White Salmon Planning Commission Meeting
A G E N D A
July 08, 2026 – 5:30 PM
119 NE Church Ave and via Zoom Teleconference

Type II Site and Building Plan Review. A proposal for a Change of Use/Occupancy to operate a retail convenience store and minor remodel of an existing structure on a 17,250 square foot parcel in Commercial Zone, located at 211 N Main Ave, planning file WS-SPR-2026.003.

TYPE II STAFF REPORT FOR SITE AND BUILDING PLAN REVIEW

Parcel Number: 03111932000400
Legal Description: Tax Lot 27 in NWSW Less Tax Lots 27B & 27A Irregular Tracts to WS;
19-3-11
Planning File: WS-SPR-2026.003

Figure 1: Possible drainage issue shown with red arrow

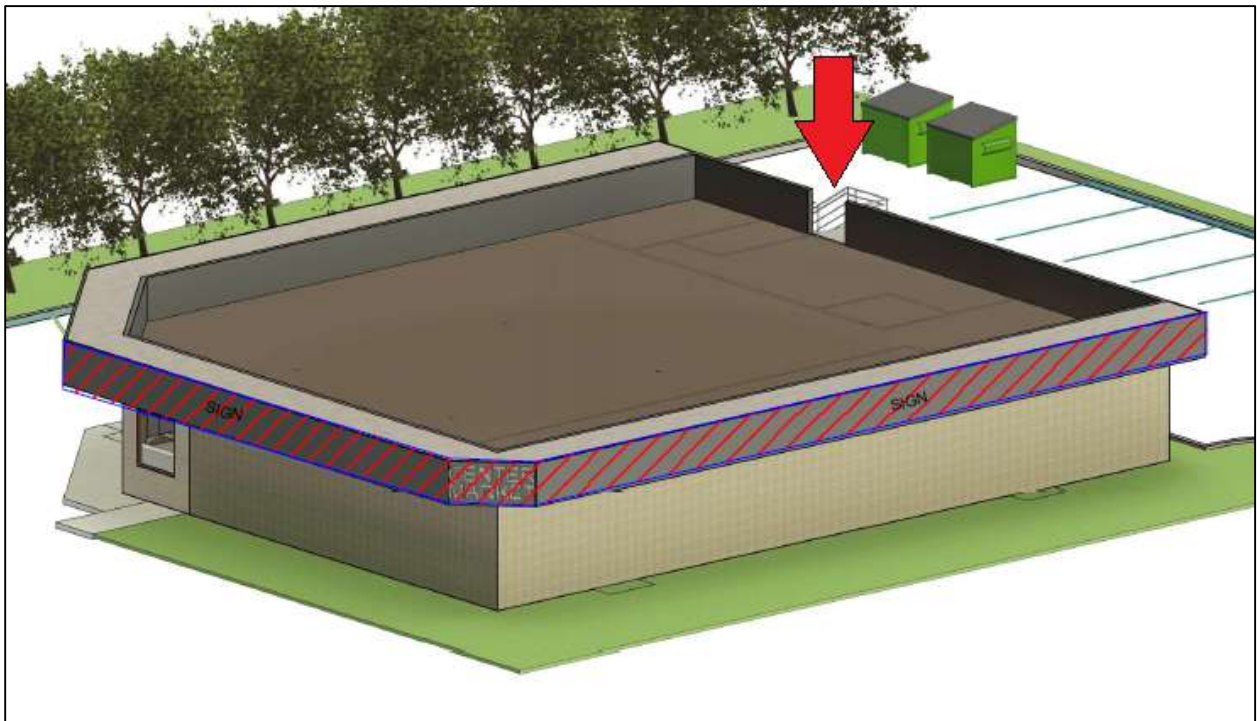
This is an existing structure except for the minor addition on the northwest corner. No new impervious surfaces are proposed, so the total amount of stormwater runoff will not change. The rendering shows the awning as a flat overhang over the main entrance, protecting pedestrians from drips. The roof parapet has an exit cut out on the east/rear side, which may concentrate stormwater runoff. There is landscaping areas on the south part of the parcel which may be able to absorb the run-off if channeled appropriately.

Condition of Approval: The applicant shall submit a surface drainage plan, to be approved by Public Works and/or the City Engineer, to ensure that stormwater runoff does not concentrate on the roof and then flow into public rights-of-way.

A1.01 SITE PLAN
3/16" = 1'-0"
0 1 2 3 4 5 10

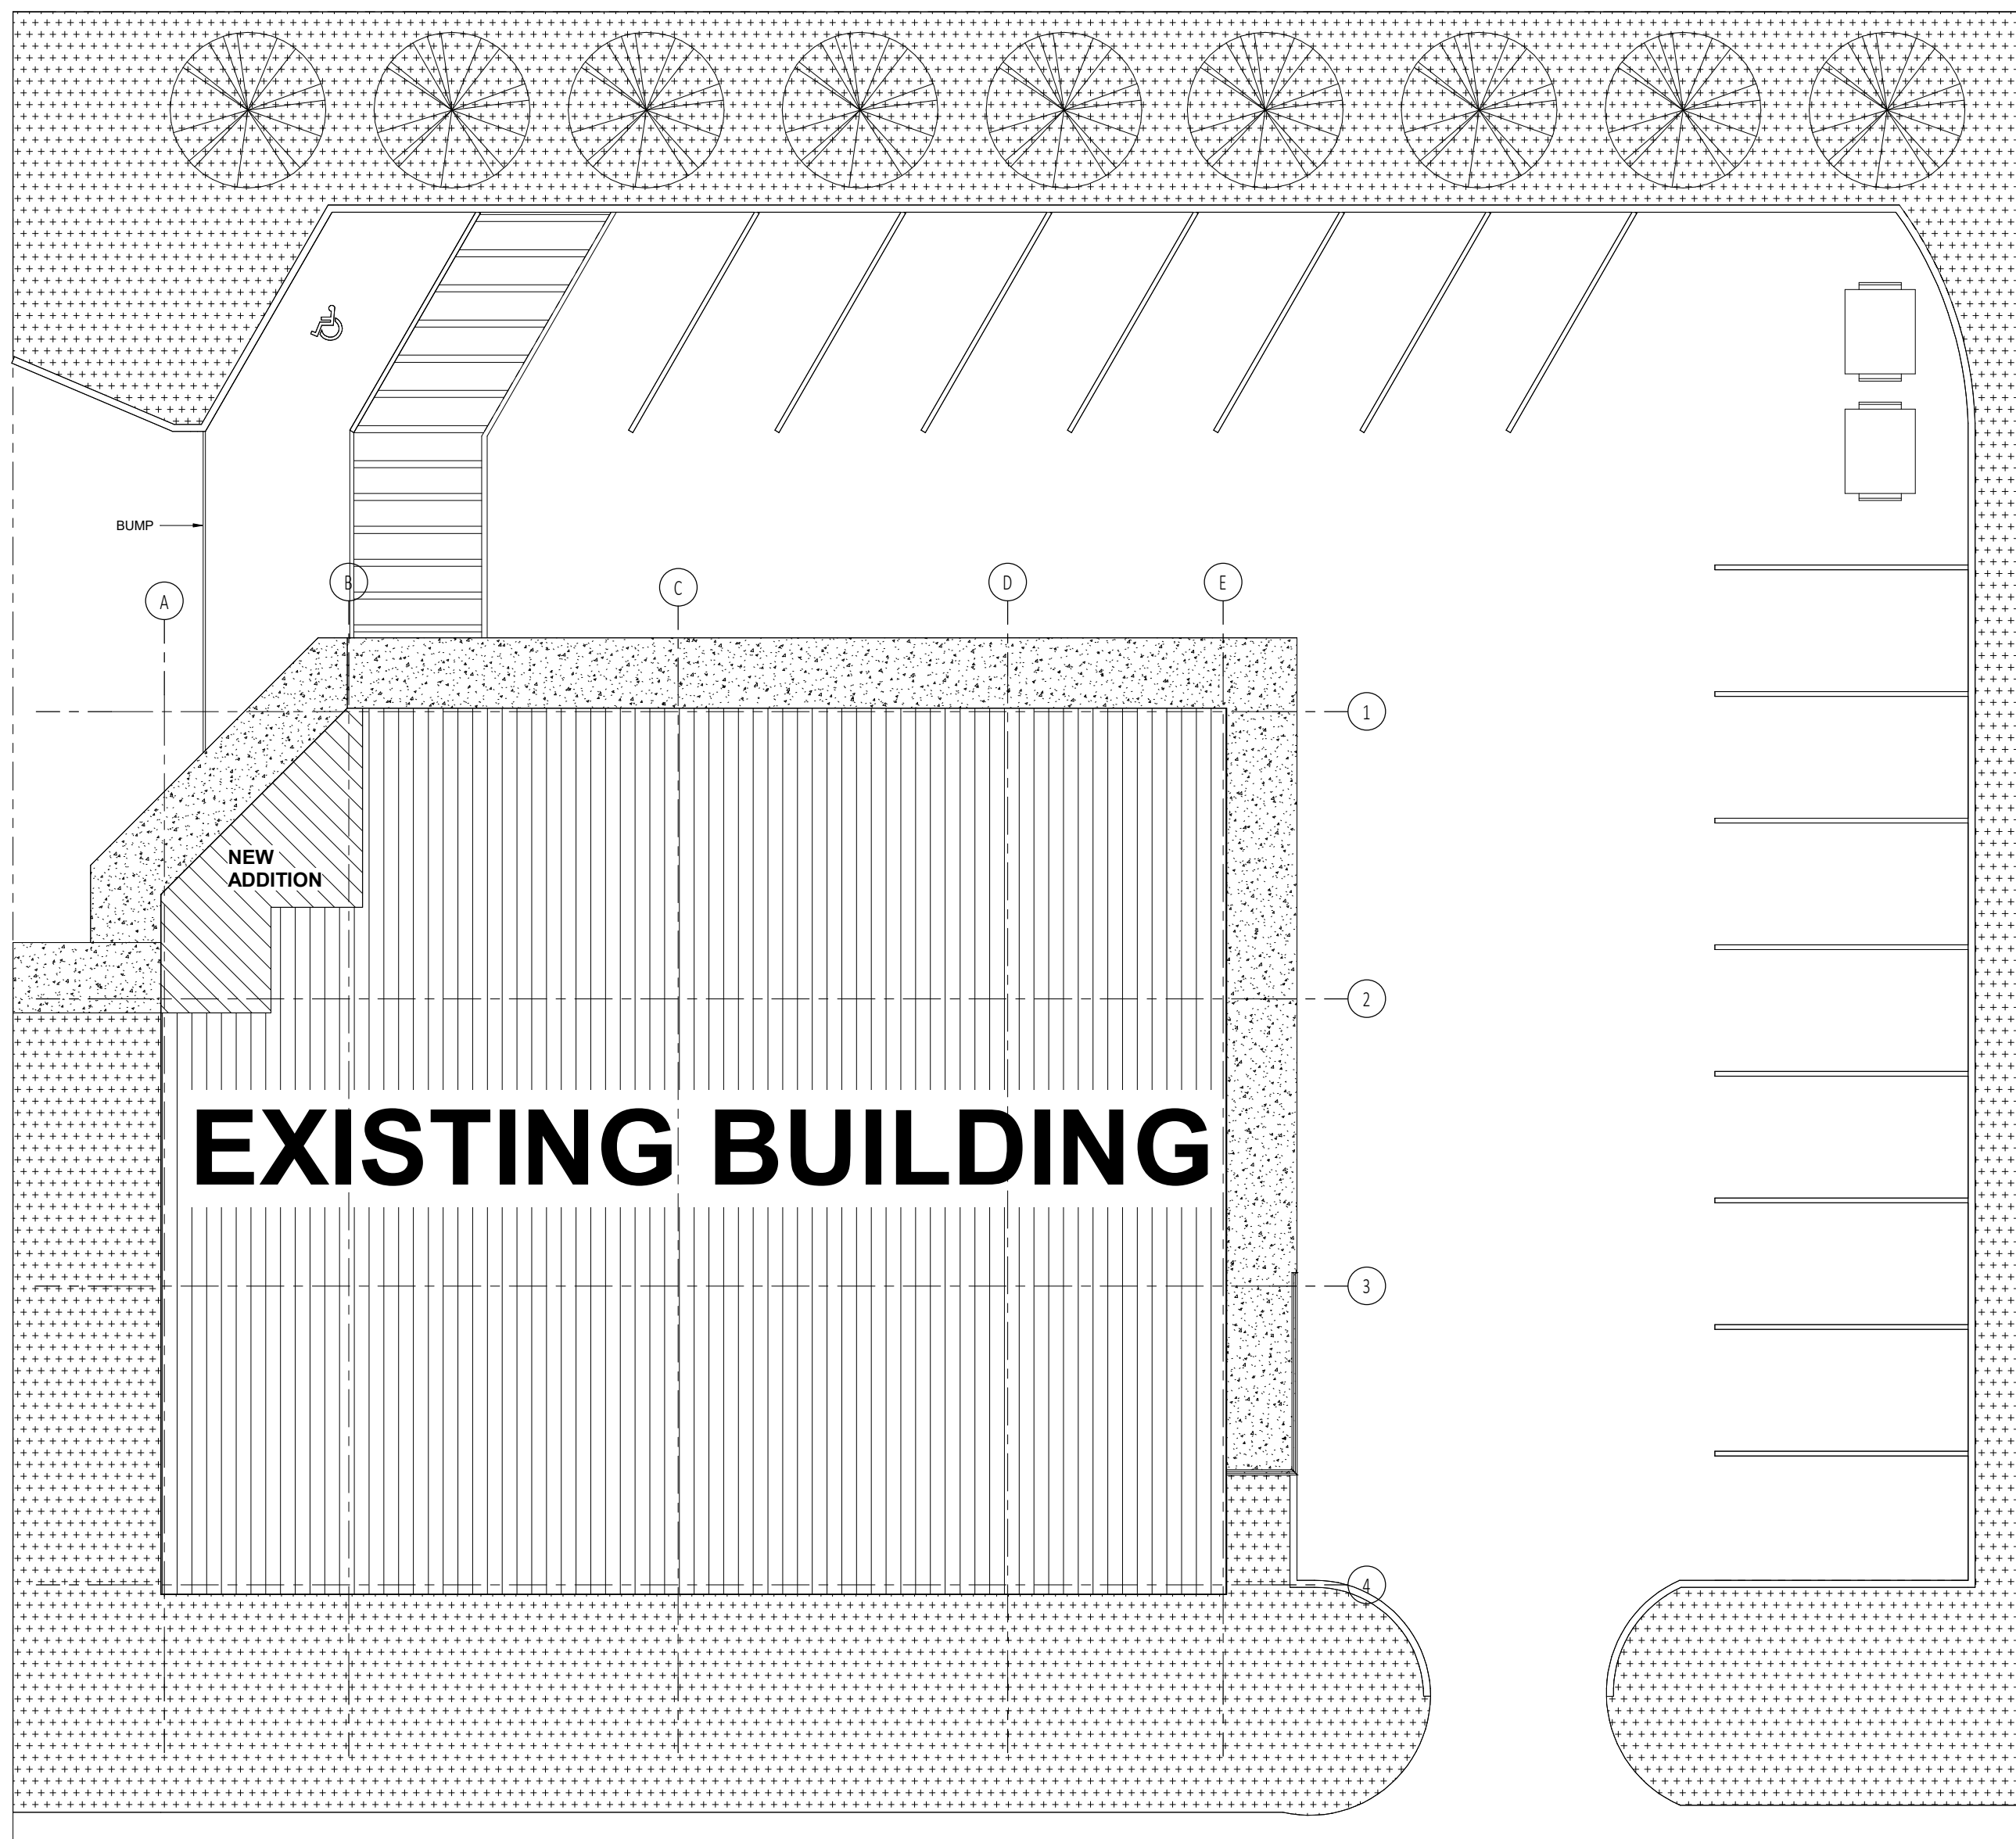
The site plans shows two dumpsters in the northeast (rear) corner of the parking lot.

The landscape planter on the north property line is at least 10 feet wide and 100 feet long, although only 1 or 2 trees might be called “shade trees” and the rest appear to be shrubs. The site plan shows nine (9) trees, but it’s not clear if this is intended as new landscaping or for illustration purposes only; no species are given. There are sixteen (16) parking spaces, so three (3) shade trees would be required to meet this standard.

Condition of Approval: Applicants shall plant at least three (3) shade trees in the landscaping areas of the parking lot.

S3.02 ROOF FRAMING PLAN

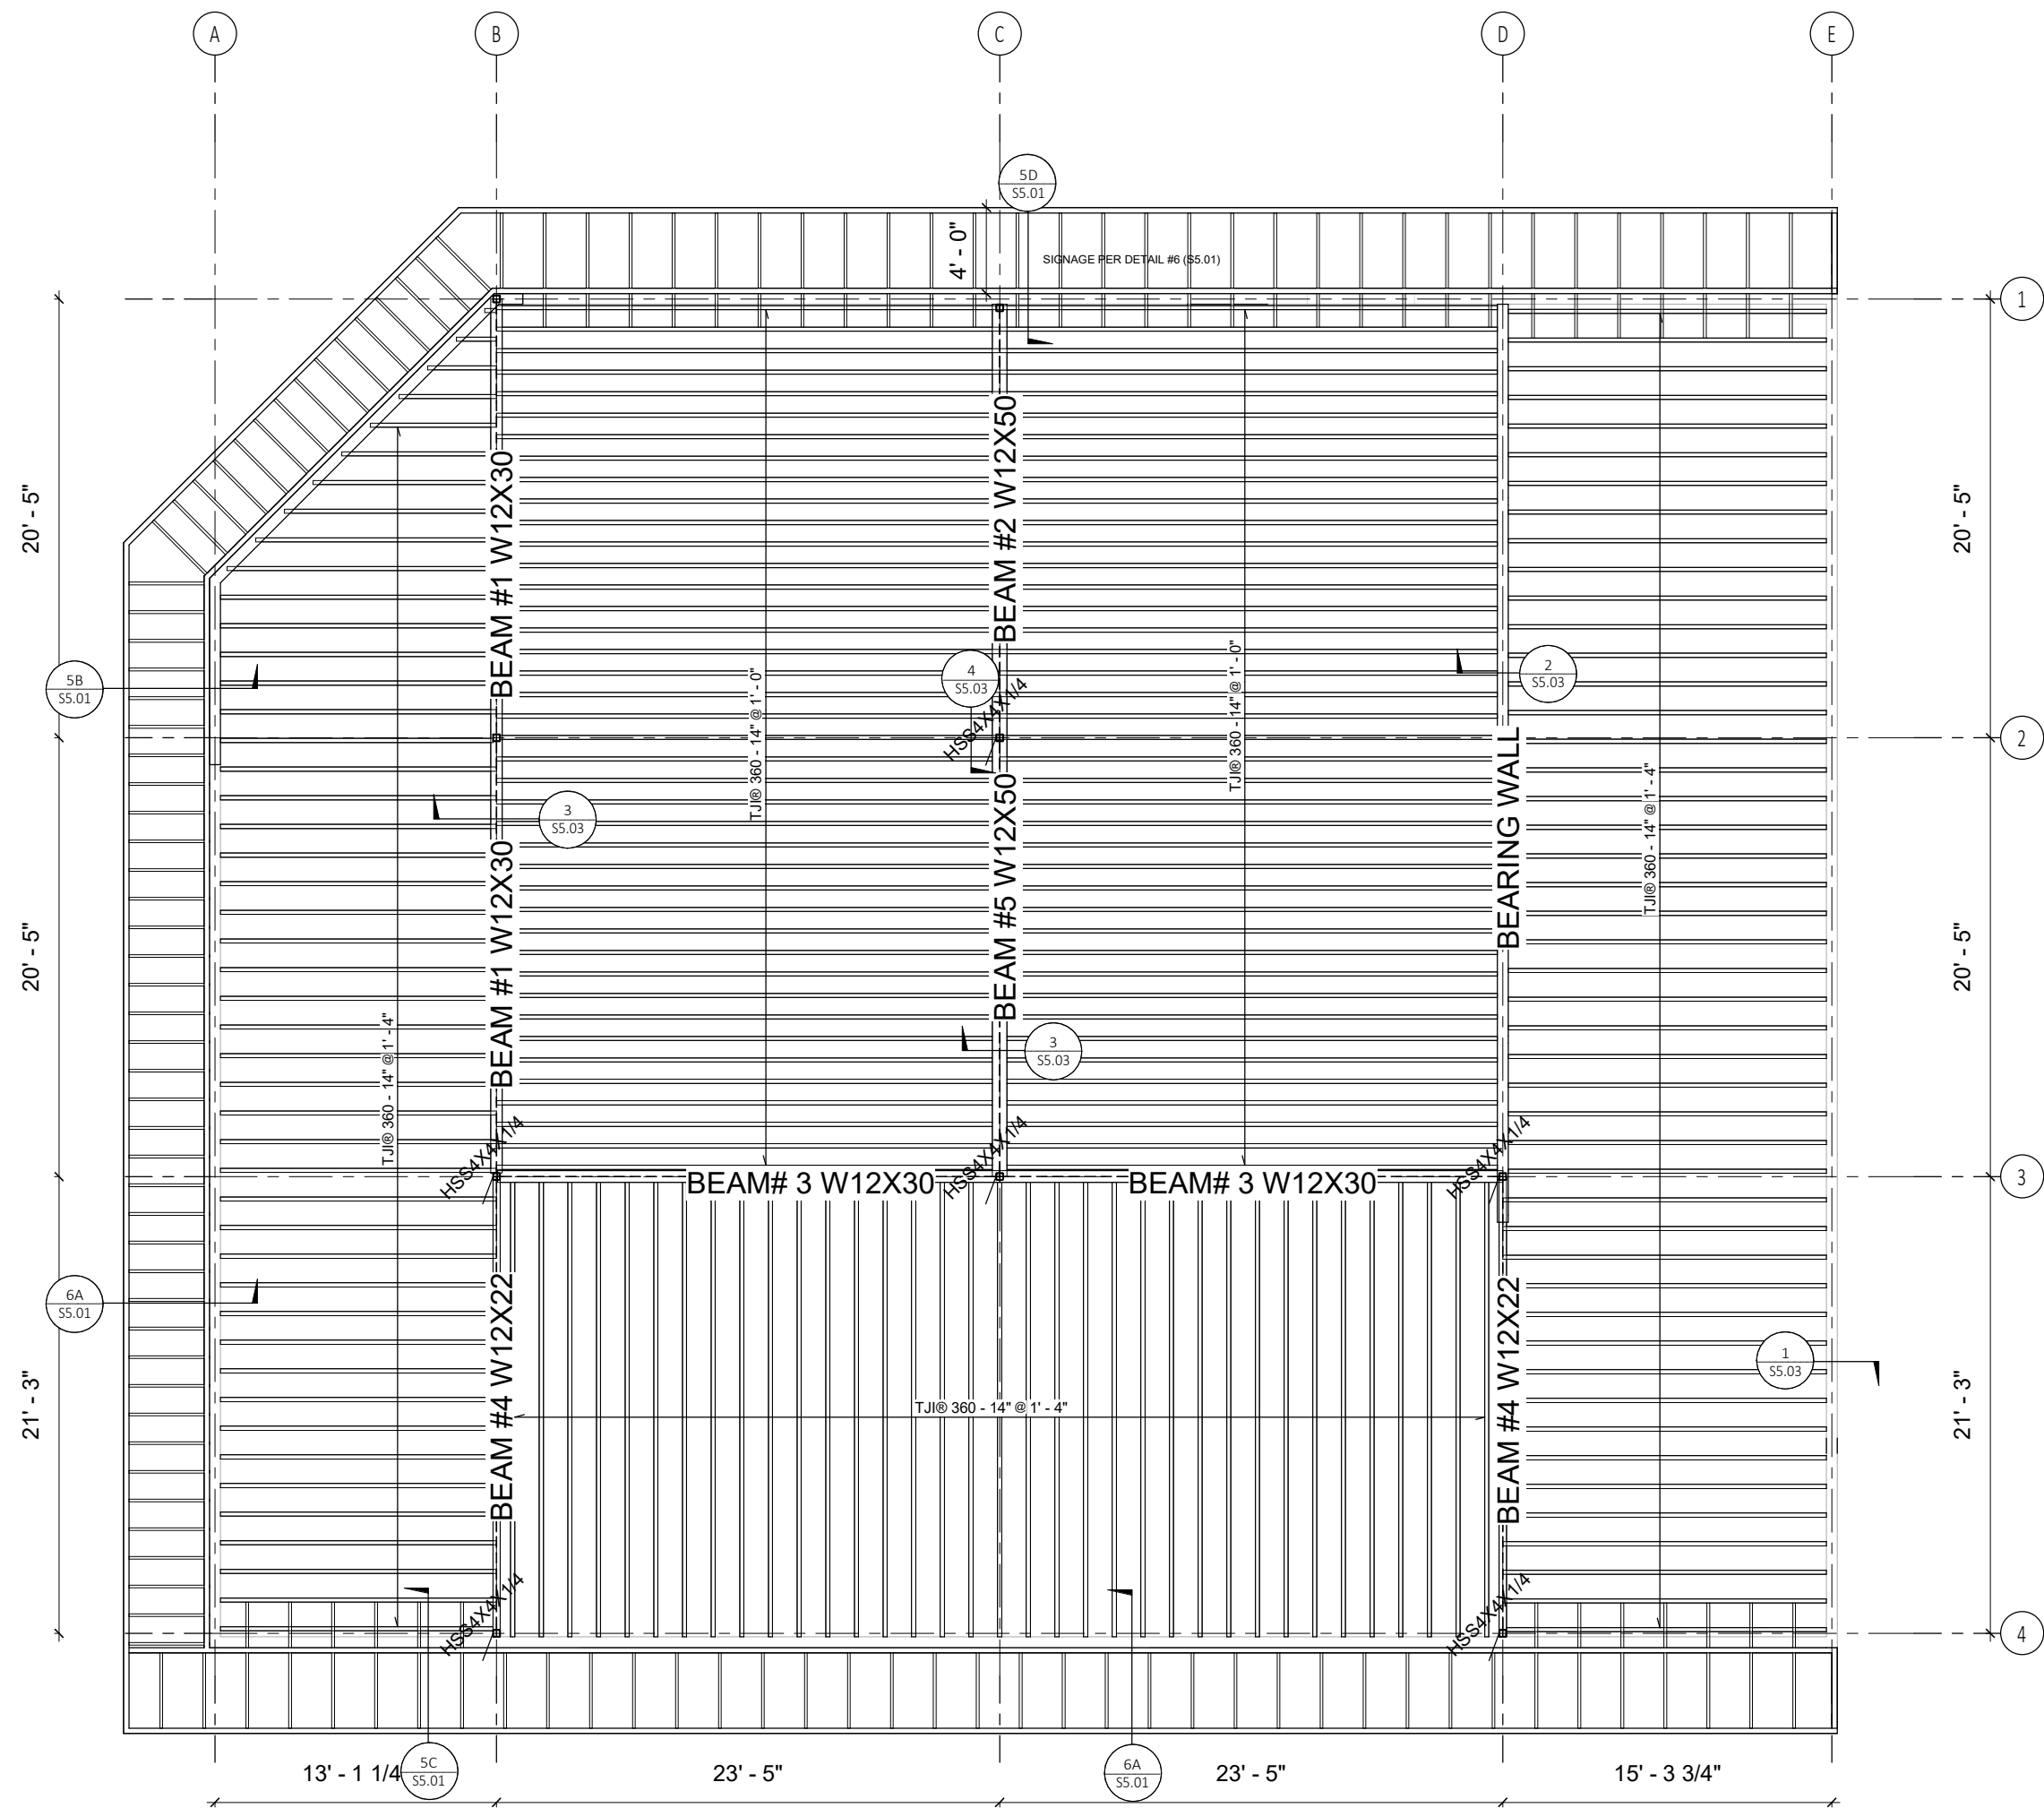
The exterior building materials and finishes will generally remain the same. The only exterior change is at the roof, as shown on the building plans. Please refer to Sheet S3.02 for that information.
